## New Barrilitos Nozzle

Technical Bulletin Reference No. 2502-001

# New Bridge Tower Power PC Board

Technical Bulletin Reference No. 2502-002

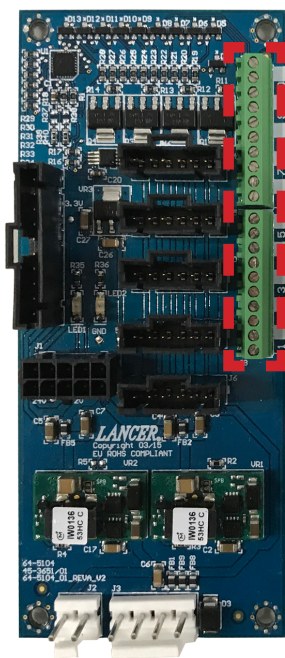
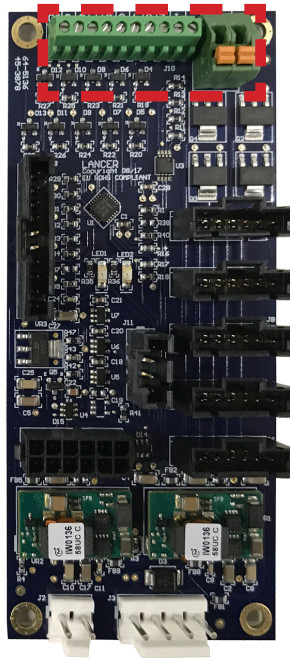
Lancer has upgraded the Power PCB for all Bridge Tower units. The new kit (Lancer PN: 82-5315) includes a new power board (Lancer PN: 64-5738) that will replace the two existing power boards, (64-5104 and 64-5124) as well as 2 new power harnesses (52-3959 and 52-3961) that will replace the existing power harness (52-3670).

Sold Out Inputs on right side of Power PCB

Sold Out Inputs moved to top of Power PCB

- Sold Out input terminals were moved to the top edge of the board to provide easier access.
- Multiple common input terminals were consolidated into two larger terminals.
- The new board includes an additional LED control output connector. This supports a brightness control for the Bridge Accessibility Display. (requires UI version 1.34 or higher).
- Added electrical protection to the dispense control PCB communication lines. These signals are now routed through the power PCB instead of going directly from the display assembly to the dispense controller.
- Improvements were made to reduce the possibility of interference due to external electrical equipment.
